Model : Finisher-E1

Ref. No. : FF-T01-W-000094-01

Subject : UPDATING THE DC CONTROLLER PCB IN RESPONSE TO THE ELIMINATION OF THE STAPLER SAFETY SWITCH (S14)

Fig. 1

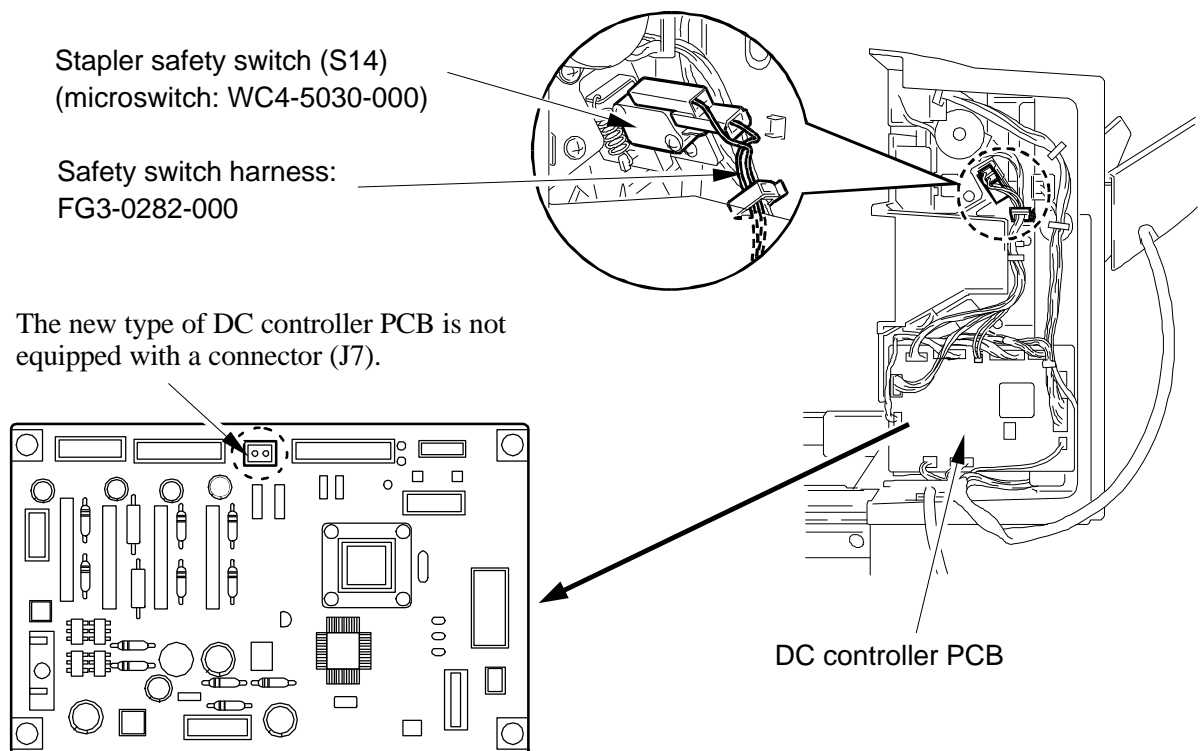
Details : The safety of the stapler unit itself has been verified* in the absence of the stapler safety switch (S14), leading to the elimination of the switch and the switch harness. With this change, the connector (J7) for the controller PCB is no longer necessary and is now removed (Figure 1).

Servicing : Be sure to remove the safety switch harness when replacing the old type of DC controller PCB (w/ connector J7) with a new type (w/o connector J7); see Figure 1.
